Up-Armored
HMMWVs...

OUT WITH THE OLD REAR CONDENSERS

New rear condenser allows for more clearance and has beefed-up panel

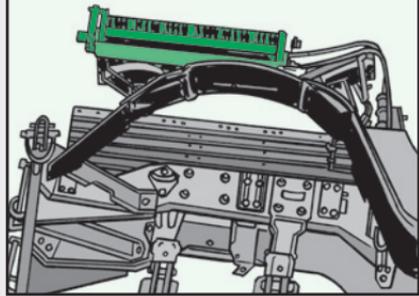
Problems in the field led TACOM LCMC to develop a new rear condenser. It allows for more clearance and has a beefed-up closeout panel. That should curb damage.

The original rear condensers, NSN 4130-01-537-4847 and NSN 4130-01-536-5561, are no longer available. But you can get the new condensers, closeout panel and related hardware in new upgrade kits that the truck headshed assembled.

ORDER THE LEFT-HAND REAR CONDENSER KIT USING NSN 2540-01-558-3448, AND THE RIGHT-HAND REAR CONDENSER KIT USING NSN 2540-01-558-3450.

AND MAKE A NOTE OF THIS IN THE TM UNTIL IT GETS UPDATED.
